Bulletin No. 2002-07

Spark Plug Fouling 3.0 Liter OptiMax

MERCURY/MARINER
2001/2002 Model 200/225 3.0 Liter OptiMax
0T178500 Thru 0T598999

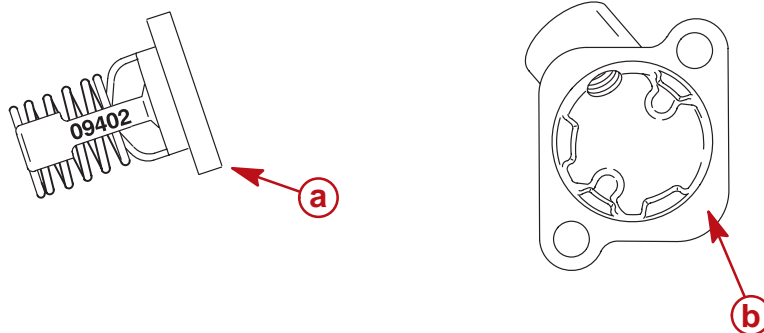
- A MAP sensor reading with the ignition key in the "ON" position prior to engine start up normally reads a higher number than when running at idle speed. MAP sensor readings that do not change with throttle changes or MAP sensor readings that keep changing when there is no change to throttle opening or engine speed are all indications of a problem.
- An air temperature sensor reading of 4° C [40° F] on a day with outside temperatures of 32° C [90° F] just does not make sense.

These are only two examples of incorrect sensor readings that would not store a fault code because the sensor is still within its normal working range. Incorrect sensor readings can contribute to spark plug fouling. Sensors furnishing incorrect readings should be replaced.

a - Rubber hose slid over spark plug for installation of plug

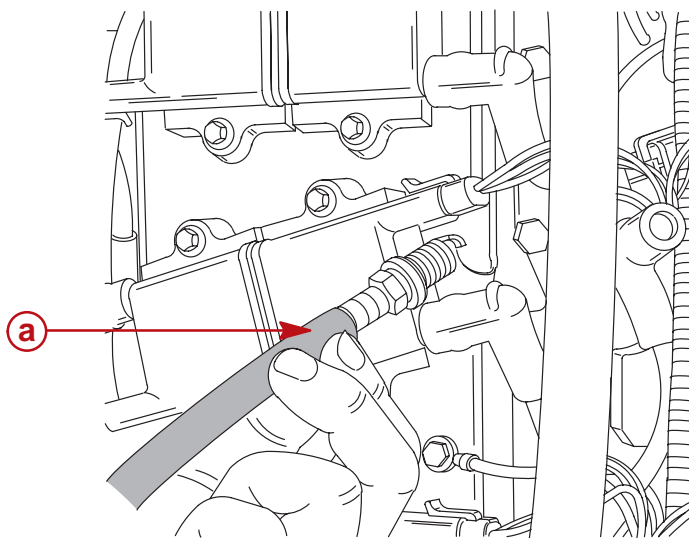
Damaged or loose spark plug wires may cause plug fouling. Most wire damage is the result of rough handling and the use of incorrect tools to remove and install wires. For more information on this see service bulletin 2001-05.

- Check that all plug wires are totally engaged onto the coil towers and the spark plugs.
- Check the spark plug wire boots for damage.

New spark plugs are normally gapped correctly, but should be checked prior to installation (plug gap 1.1 mm [.043 in.]).

NOTE: To prevent spark plug cross threading, use a piece of hose pushed over the plug. (Gray fuel hose with 8 mm [.315 in.] I.D. works well.) This will allow you to thread the plug into the spark plug hole by hand while avoiding cross-threading. Torque plugs to 27 Nm [20 lbs. ft.].
